**GOVERNMENT OF THE DISTRICT OF COLUMBIA
DEPARTMENT OF TRANSPORTATION**

MEMORANDUM

SUBJECT: ZC Case No. 15-28 – 301-331 N Street NE

Figure 1 Site Design and Access (Source: Gorove/Slade)

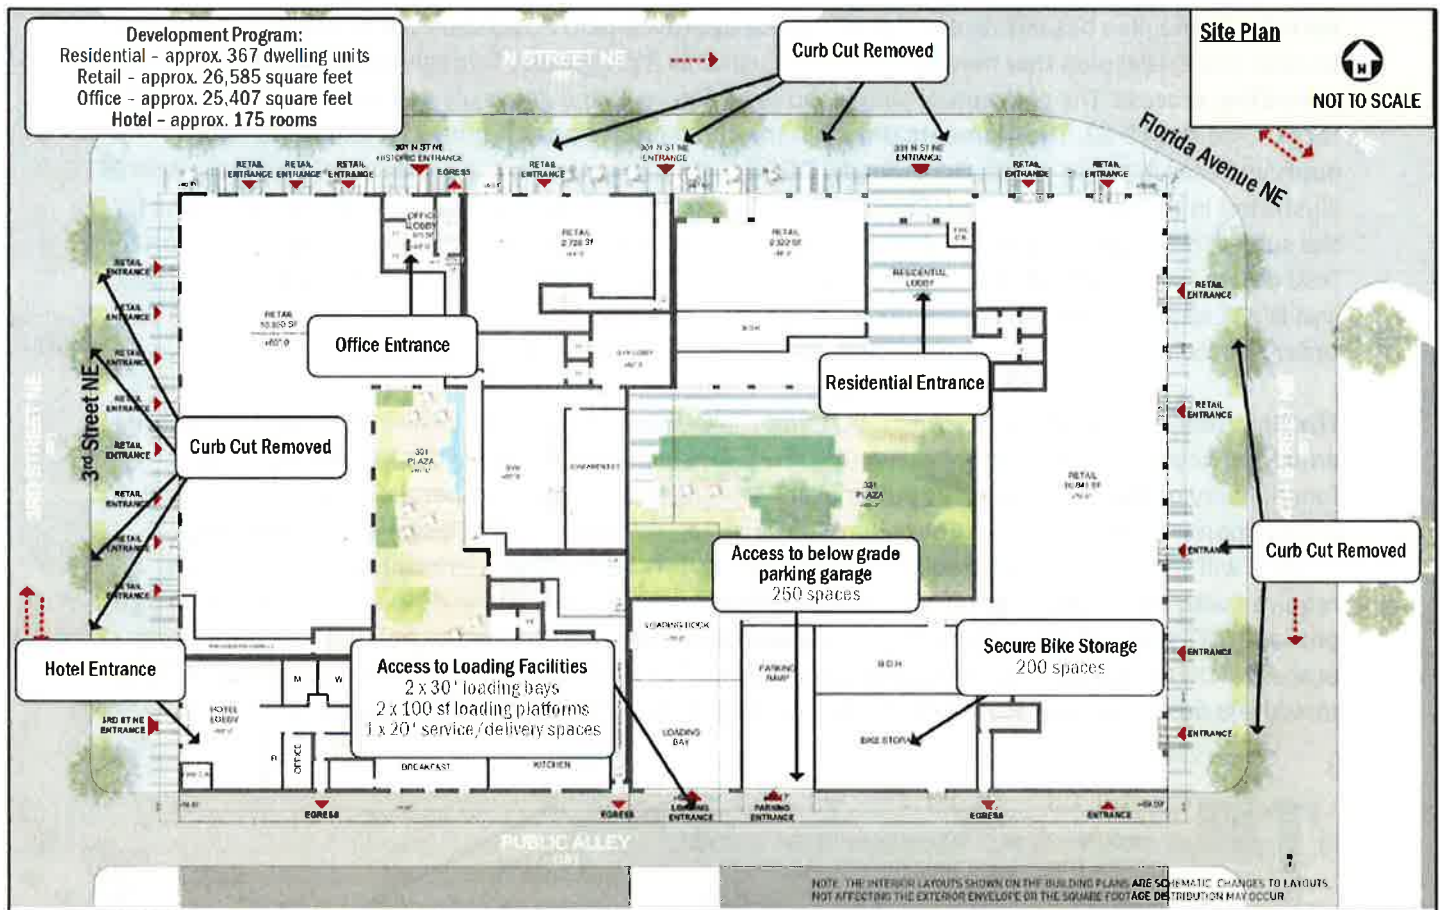
The Applicant proposes 200 long-term bicycle parking spaces in a bicycle room on the ground floor, which greatly exceeds the approximately 145 required spaces, and an additional 30 short-term bicycle parking spaces adjacent to the site. Circulation between the bicycle room and each use within the development is unclear. As shown in Figure 1, an interior connection between the bicycle room and the various lobbies is not provided.

Figure 2 Applicant's Concept for N Street Public Space (Source: Exhibit 13B)

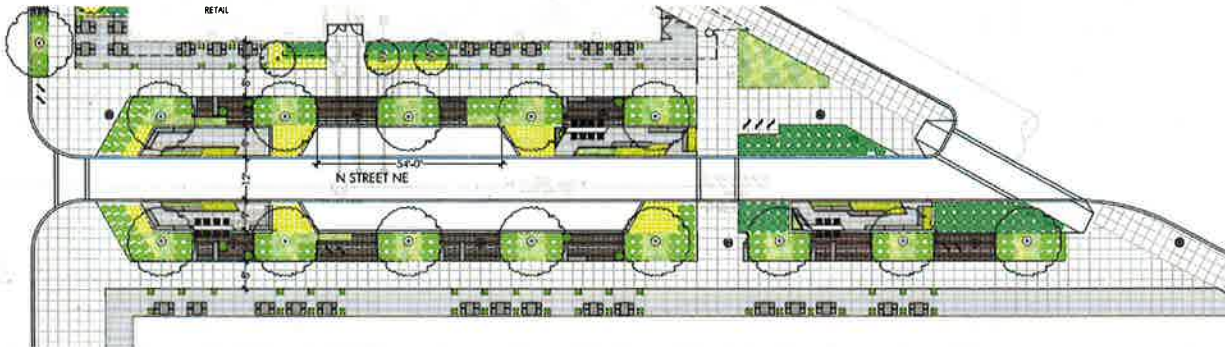
- The Applicant proposes to construct changes to N Street in coordination with ZC Case No. 15-22 to make the street more pedestrian-oriented. Design elements shown in the conceptual plan for N Street are generally consistent with approved uses in public space and DDOT does not object to the plan. The plan requires public space permits and may be adjusted as it progresses through the permitting process. The Applicant will be required to construct the N Street design as part of the public space improvements around the site. DDOT will not accept payment to construct the N Street design;

- The Applicant is required to rebuild the adjacent public space to current DDOT standards as part of their development. As such, DDOT would only consider N Street improvements in excess of the required public space improvements to be a benefit; and

All proposed elements in public space, including the N Street conceptual plan, require public space permits. As the plan has not received public space approval, DDOT considers the N Street improvements to be a conceptual plan that may need to be adjusted as it progresses through the public space permitting process. The conceptual plan is shown in Figure 2, and generally matches the plan submitted for ZC Case No. 15-22. The elements shown in the conceptual plan are generally consistent with approved uses in public space. Accordingly, DDOT has no objection to the proffered N Street changes as illustrated in the conceptual plan (Exhibit 13) and looks forward to coordinating with the applicants for the subject development and the ZC Case No. 15-22 through the public space permitting process on the final design for N Street. As a result of this further coordination, the conceptual plans may be adjusted, and DDOT requests that the Zoning Commission grant flexibility for the conceptual plan to change in order to accommodate changes identified during the public space permitting process.

- N Street & Florida Avenue intersection: DDOT will require the curbline of N Street to be adjusted such that it intersects with Florida Avenue orthogonally rather than at an acute angle.

- Curb ramps: ADA-compliant curb ramps will be required to be provided at each intersection. This includes providing a curb ramp for each crossing (typically two per corner) and ensuring that the receiving curb ramps meet standards. Curb ramps shown at alley intersections should be removed from the plans.
- Vaults: Preliminary site plans do not indicate utility vault locations. DDOT expects vaults to be located on private space in the widened alley.
